SERVICE INSTRUCTION

RUNNING MODIFICATIONS ON

ROTAX® ENGINE TYPE 912/914 (SERIES)

SI-912-020 R2

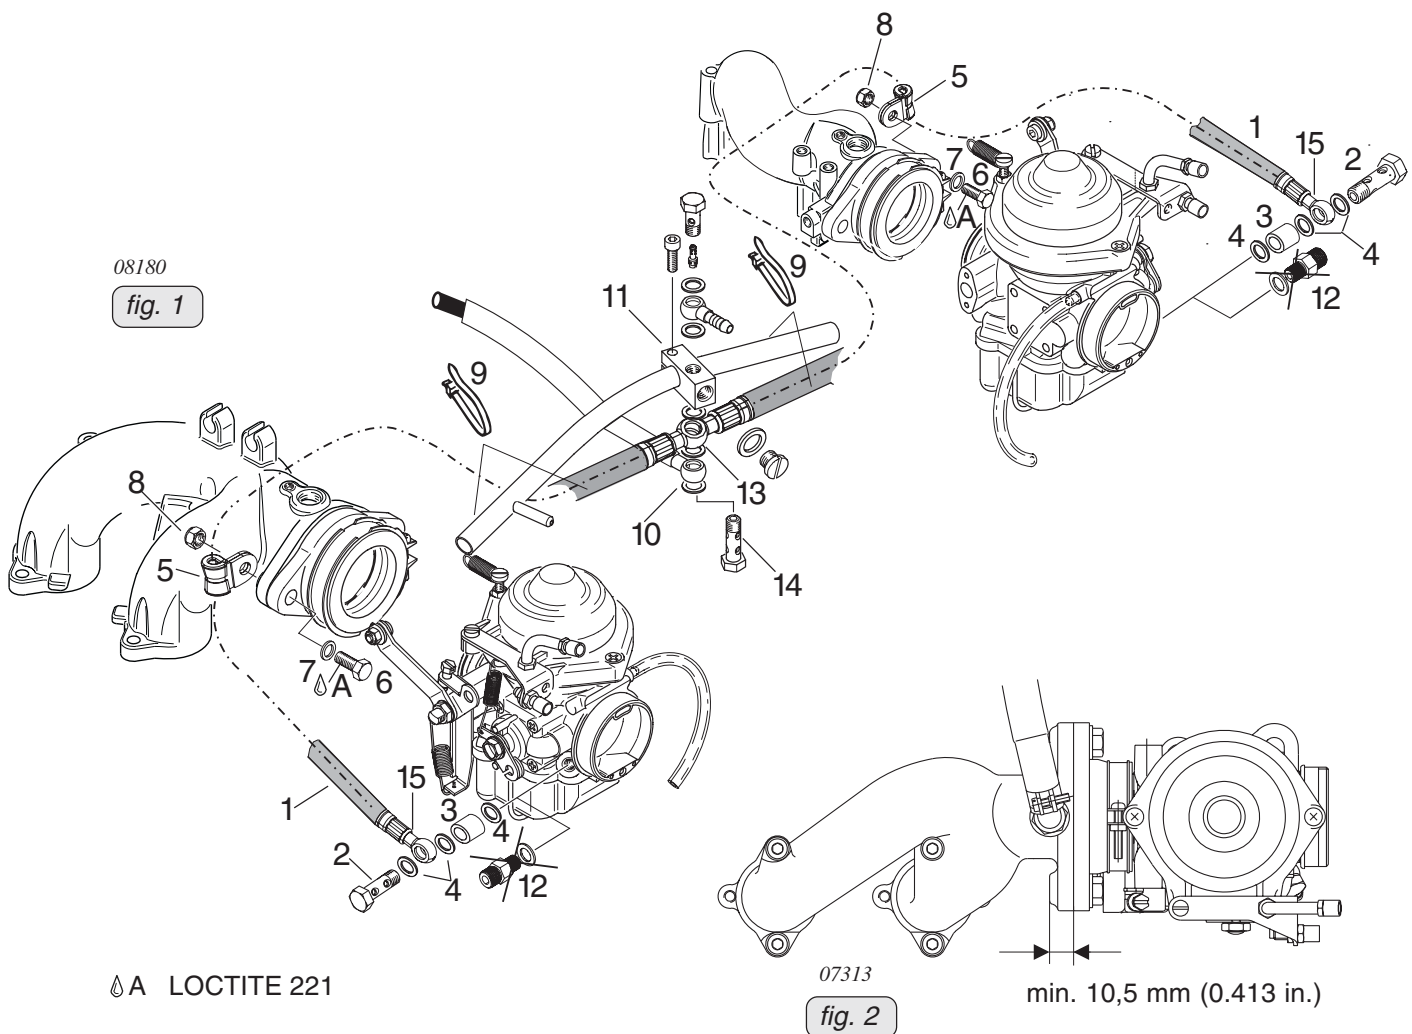
1) Introduction of a new flexible fuel line assy. part no. 874911 for ROTAX® 912 Series

In the course of continuous development and for better assembly and maintenance a new flexible fuel line (part no. 874910) has been introduced.

- mechanical machining at the intake manifold for the attachment of the cable clamp. At engine repair/general overhaul be aware that the fixation of the flexible fuel line needs an appropriate contact surface. If necessary replace the intake manifold or machine the contact surface according to the following instruction.

- Install the flexible fuel line (1) with the double ring hose nipple (13) and sealing ring (10) on the clamp block (11). Tightening torque of banjo screw (14) 10 Nm (90 in. lb.) (see fig. 1).

- Install the ring hose nipple (15) with distance sleeve (3) and sealing ring (4) on the carburetors . Tightening torque of banjo screw (2) 10 Nm (90 in. lb.)

- For installation on an old style intake manifold perform the following: Remove the intake manifold and machine the nut/clamp contact area until the surface is parallel with the sealing surface of the carb socket. The thickness of the material must not be dressed down less than 10,5 mm (0.413 in.) and should be smooth and flat so that the nut/clamp assembly has an even contact surface (see fig. 2).

- Ensure proper support of the flexible fuel line. Install Hex. screw (6) and washer (7) with 15 Nm (133 in. lb.). Install the cable clamp (5) at the hex. screw (6) of the carburetor socket with the hex. nut (8). Tightening torque of hex. nut (8) 24 Nm (213 in. lb.)

- **CAUTION:** While tightening hex. nut (8), hold hex. screw (6) with a wrench to prevent it from loosening. Always fix the flexible fuel line at the compensation tube with clamps (9) in such a way that no wear is possible.

fig. 1

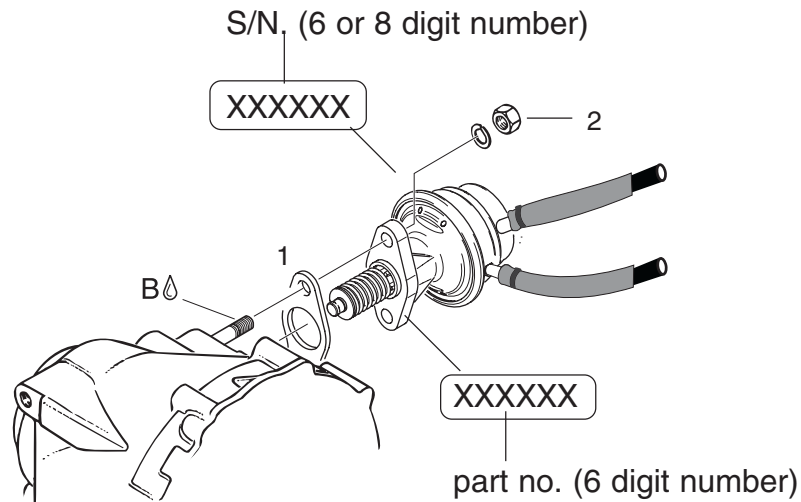
In the course of continuous development a new gasket (1) (part no. 950226) has been introduced.

The gasket is interchangeable.

- ◆ NOTE: On the sealing surfaces of the gearbox housing and the fuel pump no sealing compound has to be used.

fig. 1

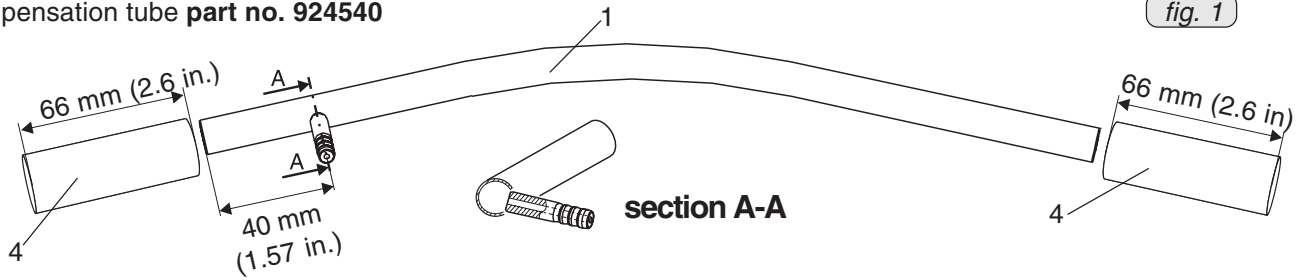
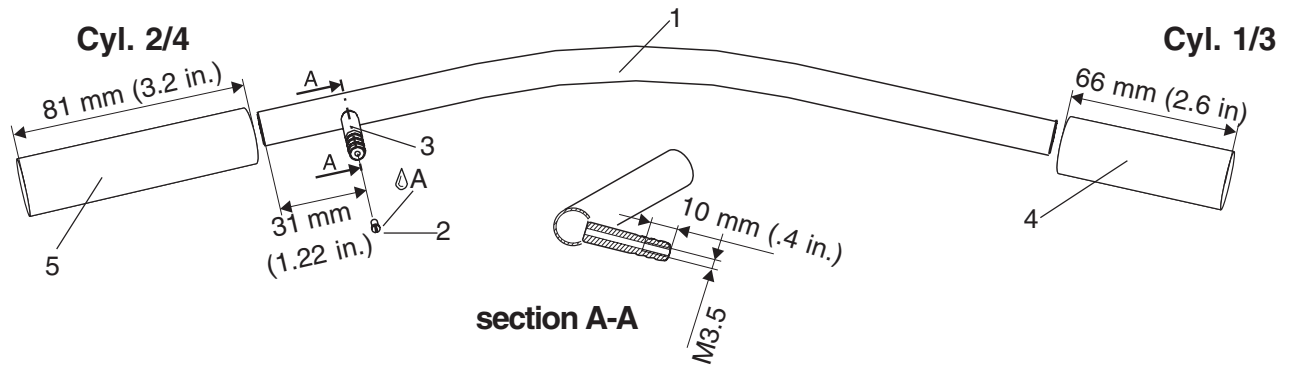
In the course of continuous development a new compensation tube (1) (part no. 924541) has been introduced which the synchronization to make it easier, the tube must not removed.

- position of connection fitting (3) on compensation tube remains approximate constant
- additional screw (2) part no. 940980 for connection fitting (3)
- new tube (4) part no. 956143 (5) part no. 956141

◆ **NOTE:** In case of interchangeable it is not possible to exchange individual parts. The new compensation tube are only **together** interchangeable with the tube part no. 956141. In case of spare parts the relevant configurations must be observed.

fig. 2

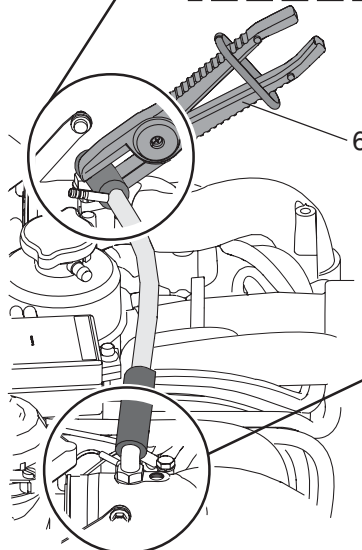
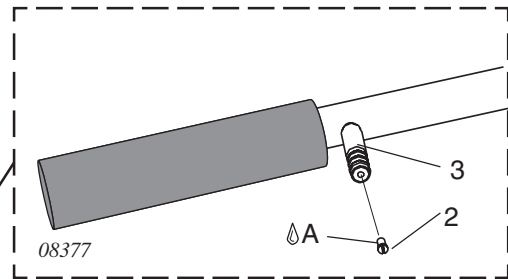
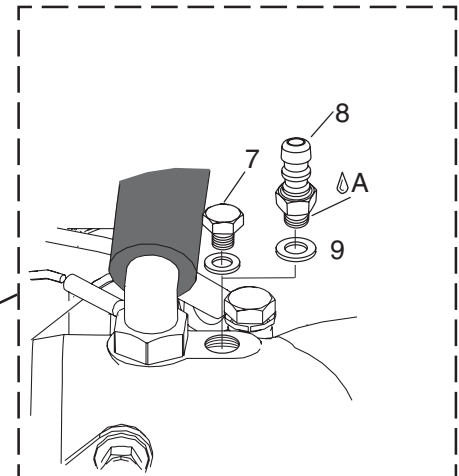
The two carburetors are adjusted to equal flow rate (mechanical or pneumatical synchronisation) has to be performed in accordance with the relevant Maintenance Manual ROTAX® 912/914 and following changes must be observed:

1. Install the vacuum gauge.
2. Clamp the tube with hose clamping pliers (6). Observe the position! The tube (1) must not removed.
3. Unscrew the screw (7).
4. Install the hose nipple M6 (8) with the sealing ring (9).
5. After synchronization tightened the screw M6x6 (7) with LOCTITE 221.

fig. 3

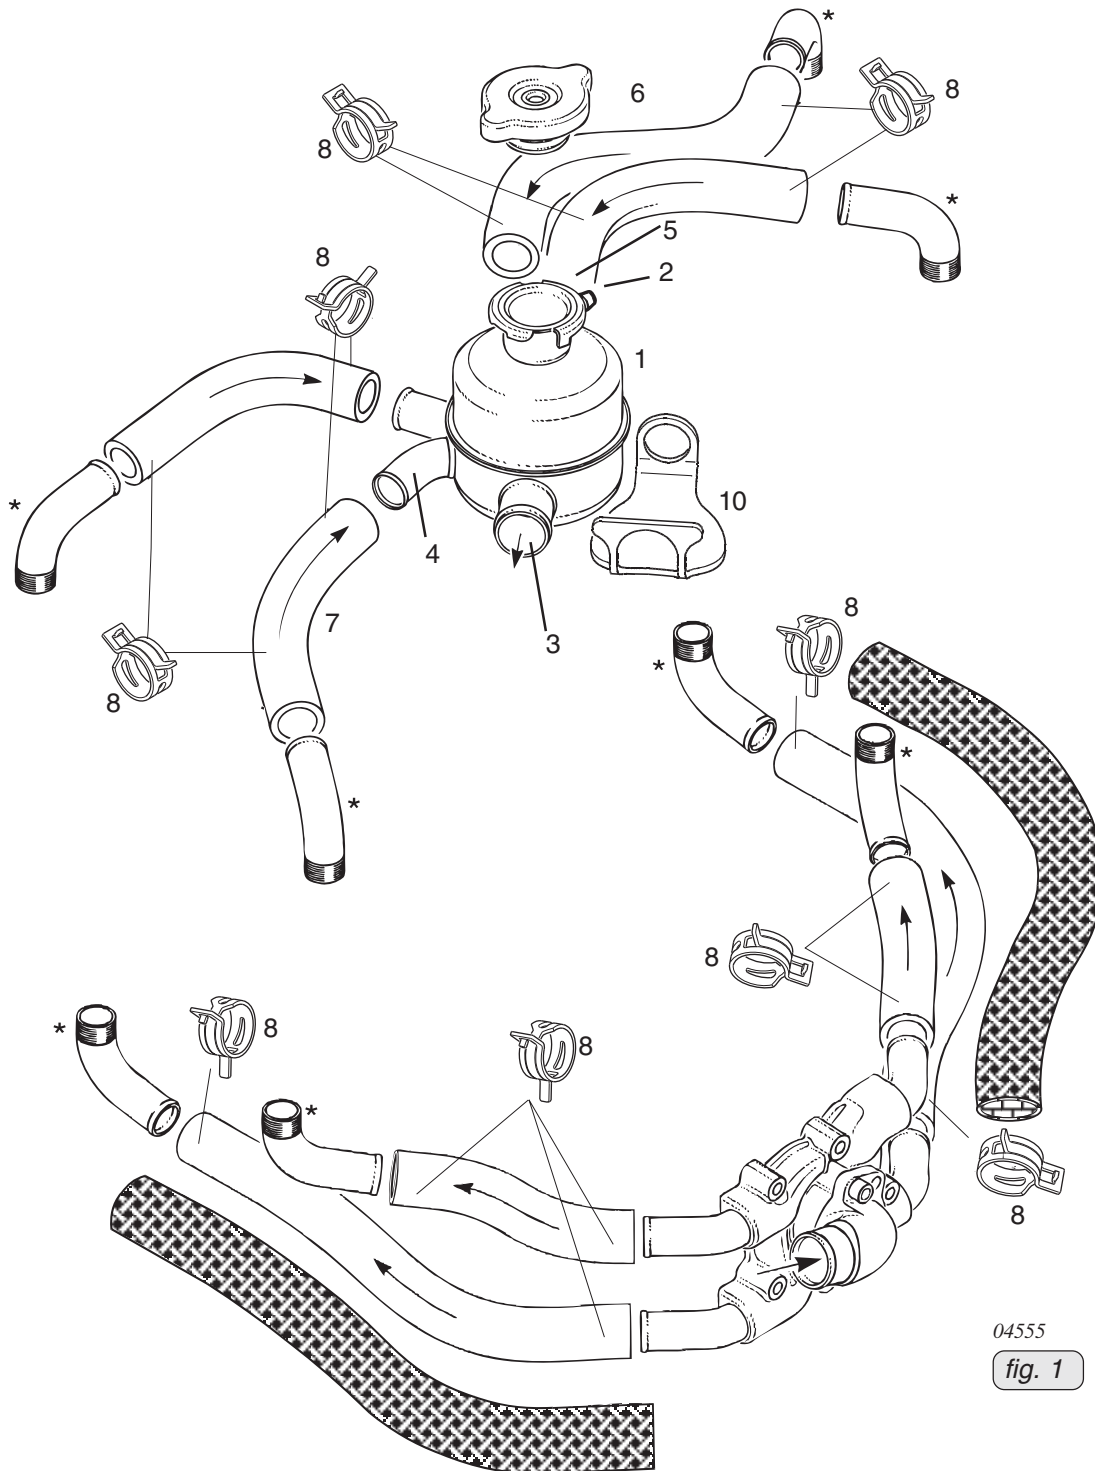
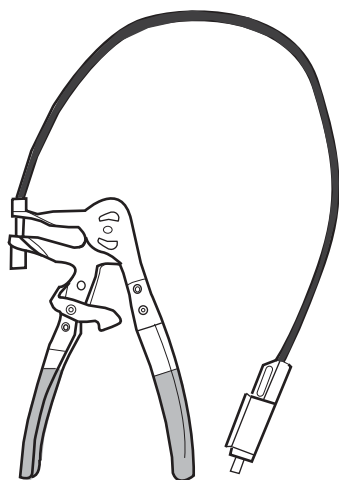
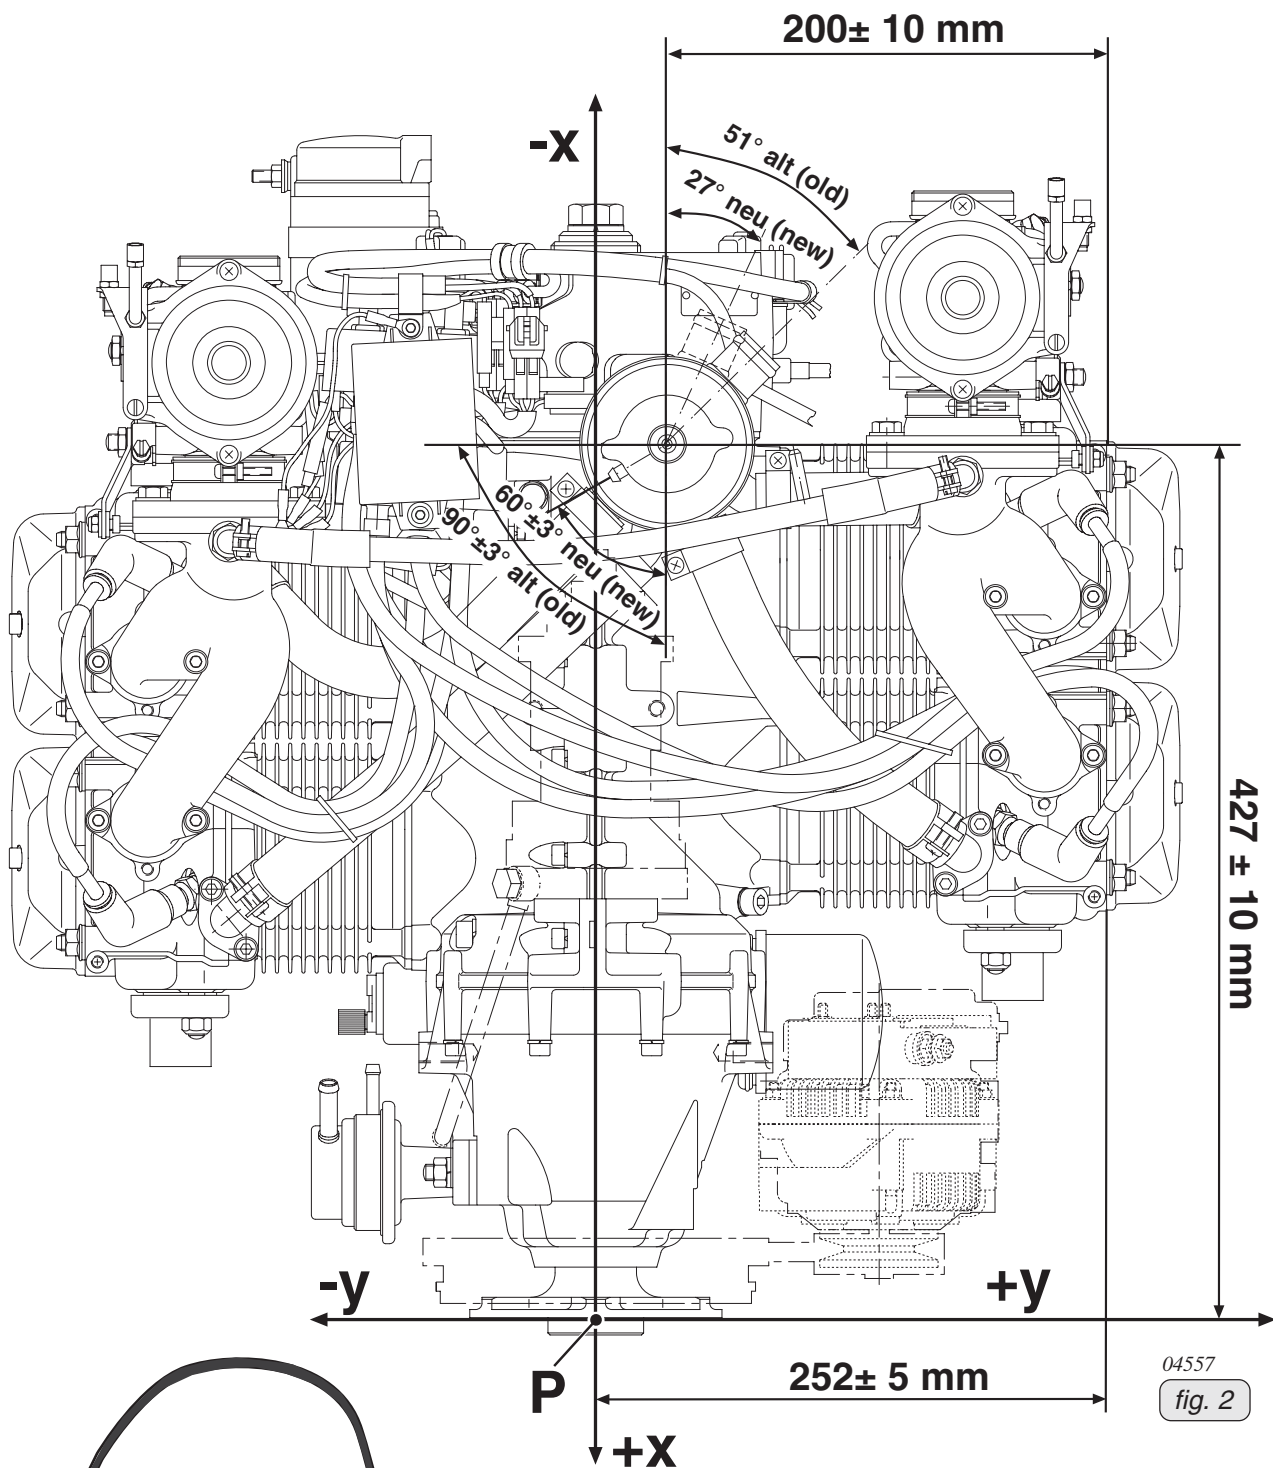
In the course of further development and standardization the position of the expansion tank (1) has been optimized!

- position of connection (2) to overflow bottle (from 0° to 30±3°)
- position of connection (3) to radiator (from 51° to 27±3°)
- angle of inlet socket (4) from cylinder 4 (34° inclined)
- length of inlet socket (5) from cylinder 3 (length increased by 13,4±3 mm)
- length of coolant hose (6) from cylinder 1 (length increased from 270 mm to 285 mm)
- length of coolant hose (7) from cylinder 4 (shortened from 100 mm to 85 mm)
- new spring type hose clamps (8) to attach the coolant hoses (expansion tank and water pump)

- Install the coolant hose (6) 285 mm to cylinder 1 and the new coolant hose (7) 85 mm to cylinder 4. For attaching all the coolant hoses from expansion tank, water pump, cylinders, use the new spring type clamps.

■ **CAUTION:** Take care of appropriate slip-on length of the coolant hoses on the corresponding connection socket. Verify tight fit of clamps and hoses and check for leakage. Always fit the clamps such that they can not wear on any component and use a suitable tool (see fig. 3) for fitting them.

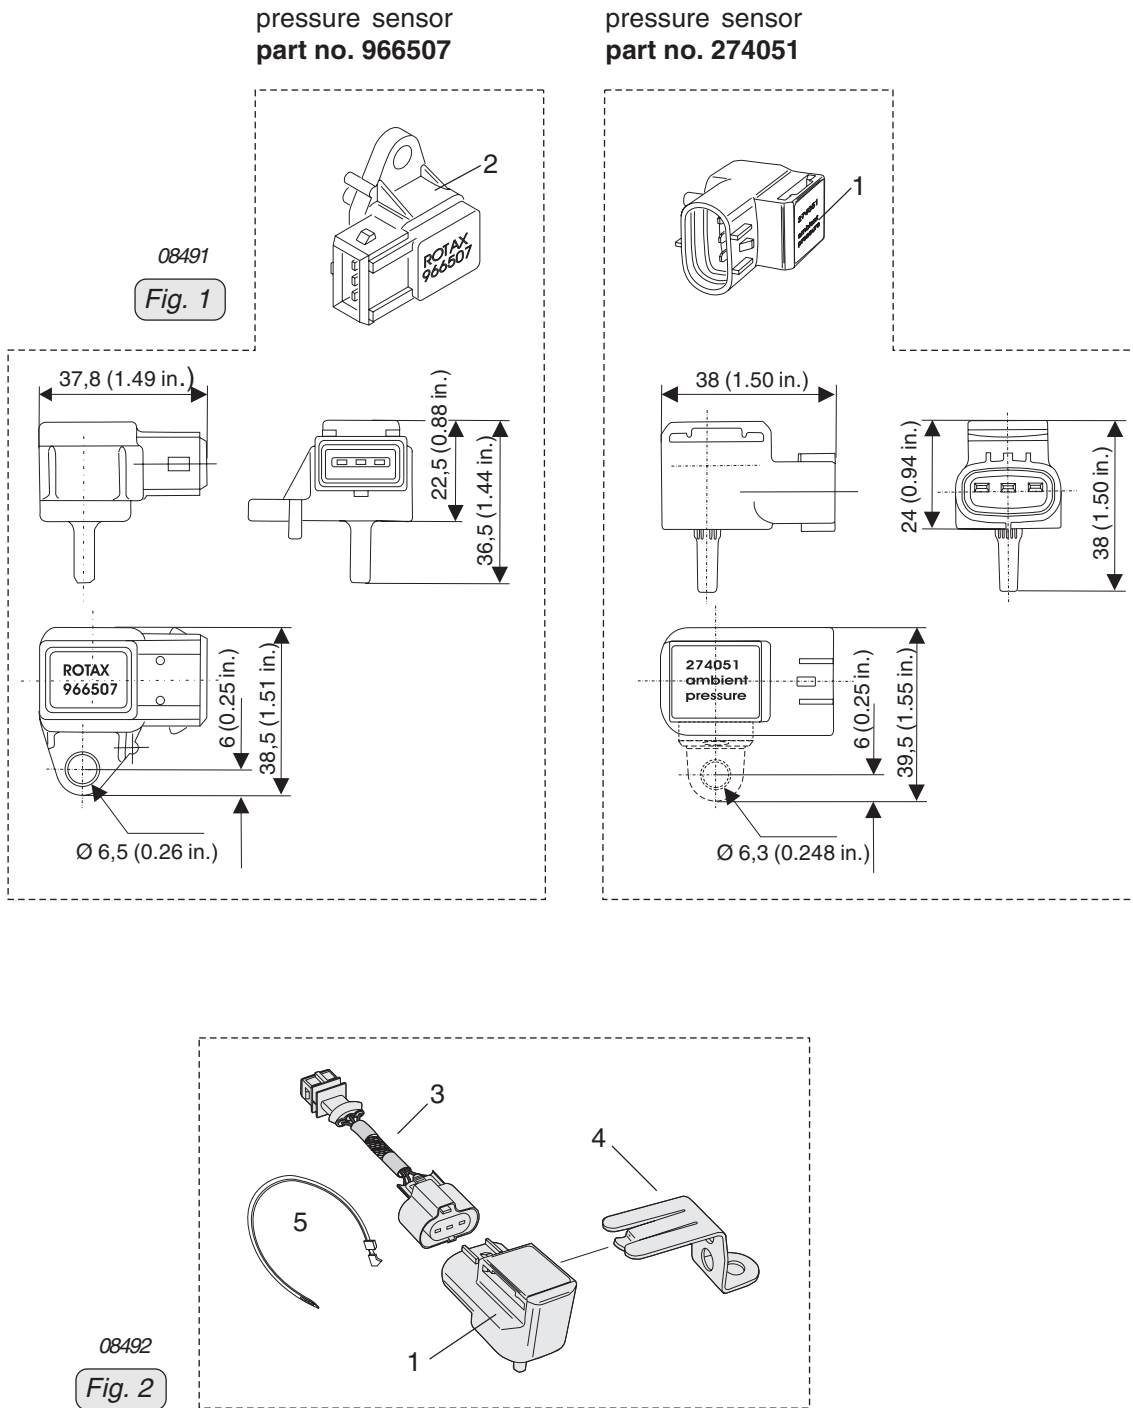
Due to the termination of production of the ambient pressure sensor (part no. 966507) a new ambient pressure sensor part no. 274051 has been introduced. The new ambient pressure sensor is of different size and also has a different connector. The connection for the wiring harness had to be changed.

1. Disconnect the pressure sensor (2) from the wiring harness.
2. Connect adapter cable (3) to wiring harness and to the new pressure sensor (1).
3. Install bracket (4) onto pressure sensor.

■ CAUTION: Route all wiring as such that there will be no sharp bends or chafing.
4. Position adapter cable and secure with cable binders (5).

new Version

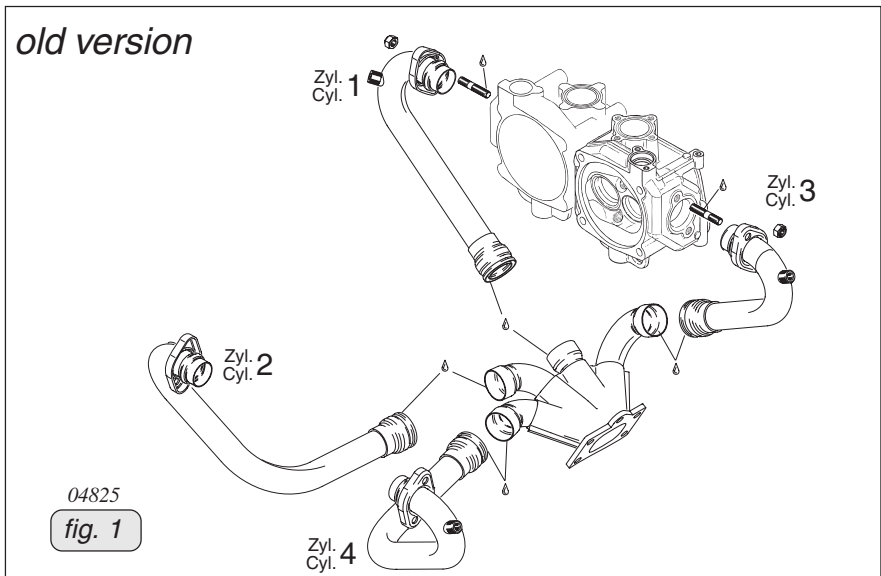
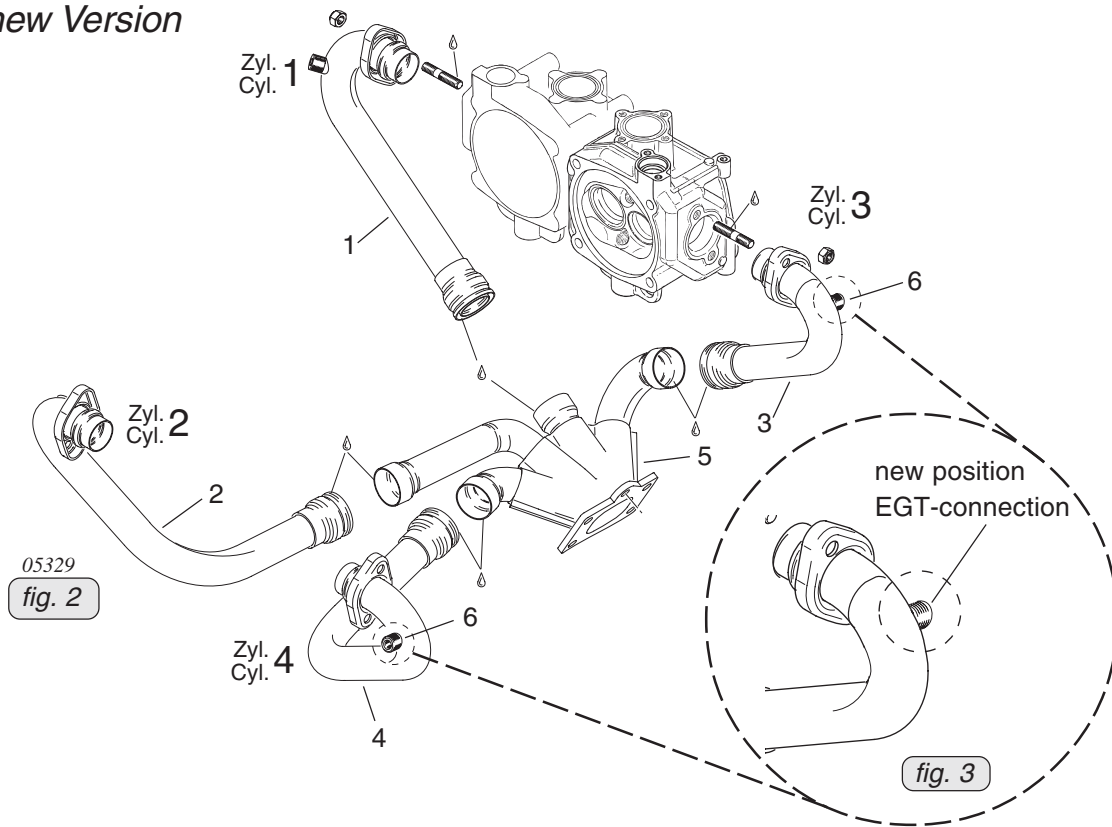
Owing to continuous further development, the exhaust bends were slightly re-worked. The couplings were optimized for their position.

- Position of the EGT connections (6) to the exhaust bends for cylinders 3 and 4 were routed such that installation of the new drip trays is possible.

◆ NOTE: If replacement of any single old part number is necessary, you must replace it with the same old part number. If the old part number is not available, the entire assembly including all 4 pipes and manifold must be replaced with new part numbers. New style pipes and manifold are not interchangeable with old style.
